Manuscript: EarthCARE Cloud Profiling Radar Observations of the Vertical Structure of Marine Stratocumulus Clouds – Point to point response to reviewer 2 comments

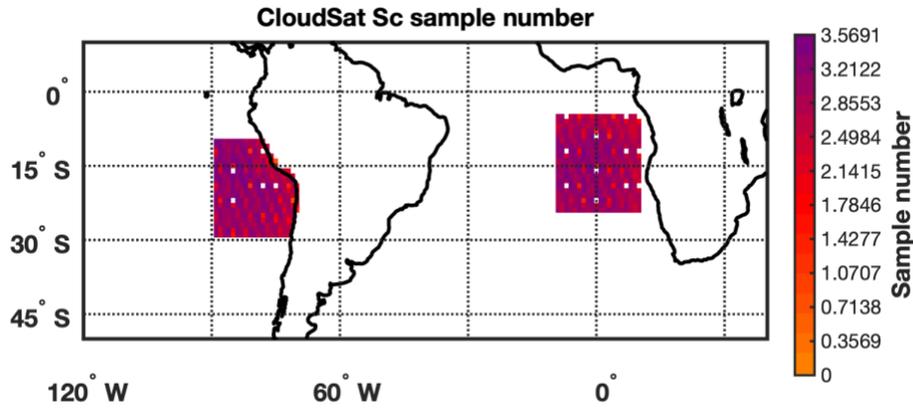
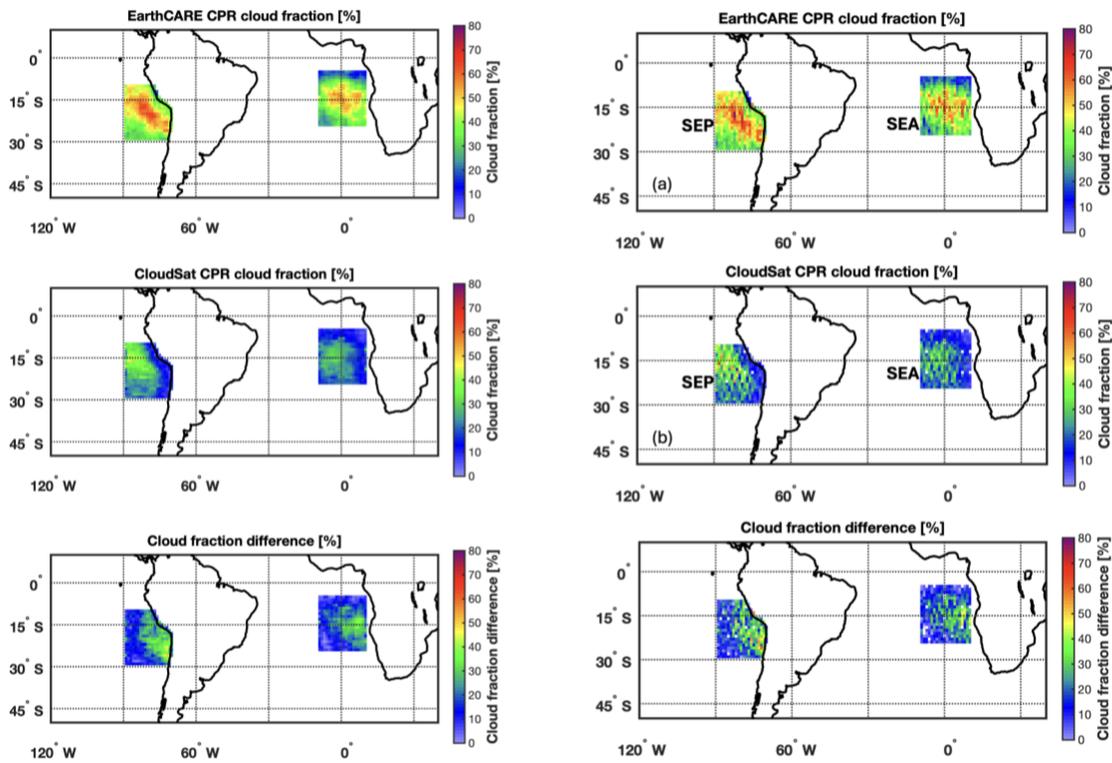
Line 116. I am a little surprised you were able to use a 1 x 1 degree grid with the CloudSat data. The fix-repeating orbit yields a ground-track spacing that is more than 1 degree between tracks at the equator. If you look at the number of CloudSat samples in each 1x1 degree bin, is there anywhere close to uniform coverage. In general, you might comment on the average number of orbits (transects) contributing to the data in each 1x1 degree grid to provide some sense for the sampling uncertainty in the cloud fractions shown here.

Yes, you are right. For CloudSat data we noticed some bins have low sample number using 1x1 degree bins. A 2D box smoothing was applied only in generating Fig. 1, so no impact on the analysis in the remainder of the manuscript (also added to the caption). The sample number on log base 10 scale in each 1x1 degree bin is shown below.

The following figure shows the spatial maps before (right column) and after (left column) the 2D box smoothing. The main message we attempt to convey is not affected by the smoothing. Note the range of color bar is 0-80% here, whereas the range of color bar in the Fig. 1 of the manuscript is 0-60%.

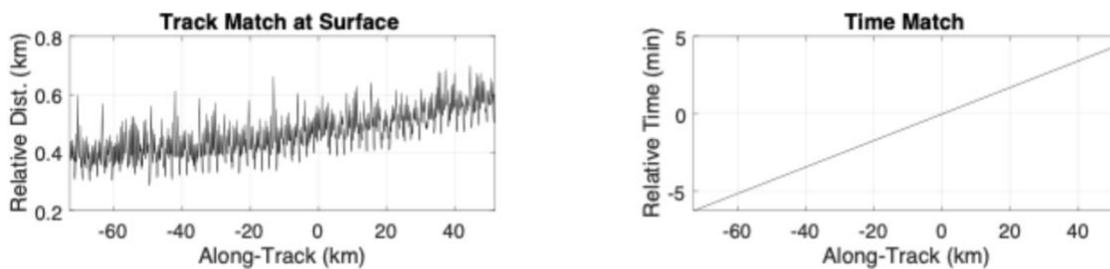
Line 221. How close (in space/time) are the ground tracks shown here? Clearly, they can't be too far off.

The track and time match are shown below. The x-axis is the same as in Fig. 5(a) of the original manuscript. We also added "The RMS of ground track match was 429 meters, and the relative time was -7 to 5 minutes." to the manuscript.
